**WORCESTER TOWNSHIP PLANNING COMMISSION MEETING
WORCESTER TOWNSHIP COMMUNITY HALL
1031 VALLEY FORGE ROAD, WORCESTER, PA 19490
THURSDAY, AUGUST 24, 2017, 7:30 PM**

Reference: 1458 Hollow Road – Minor Subdivision Plan
(Worcester Township LD 2017-06)

RE: **Traffic Review #1 – Preliminary/Final Plan of Subdivision**
Addesso Minor Subdivision (LD 2017-06)
Worcester Township, Montgomery County, PA
McMahon Project No. 817606.11

Re: MCPC #17-0199-001
Plan Name: 1458 Hollow Road
(2 lots comprising 5.50 acres)
Situate: Hollow Road (south)/Stump Hall Road (west)
Worcester Township

Center Point Mixed Use - Conceptual Master Plan
 Overlay over 'Final Land Use Bubble Plan' dated April 15, 2014
 Scale: 1" = 100'-0"

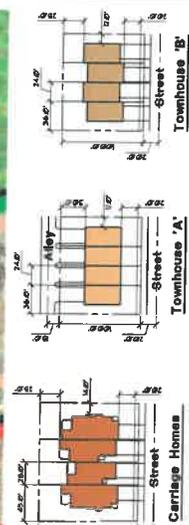
Mr. E. Van Rieker provided a sketch plan of the Palmer Tract to the Township, which we understand was favorably received by most persons. It proposed 99 dwelling units on a 48.39 acre residential tract (after deleting the areas proposed for commercial uses). That was an average of 2.04 homes per acre. The density calculation would be lower if the proposed open space on the south side of Skippack Pike would be allowed to be counted together with the northern side of Skippack Pike.

The Van Rieker sketch plan showed 27.4 acres of preserved land north of Skippack Pike within the 48.4 acre residential development area. That would result in 56.6 percent open space. Most notably, the plan proposed to preserve a substantial contiguous area of scenic farmland.
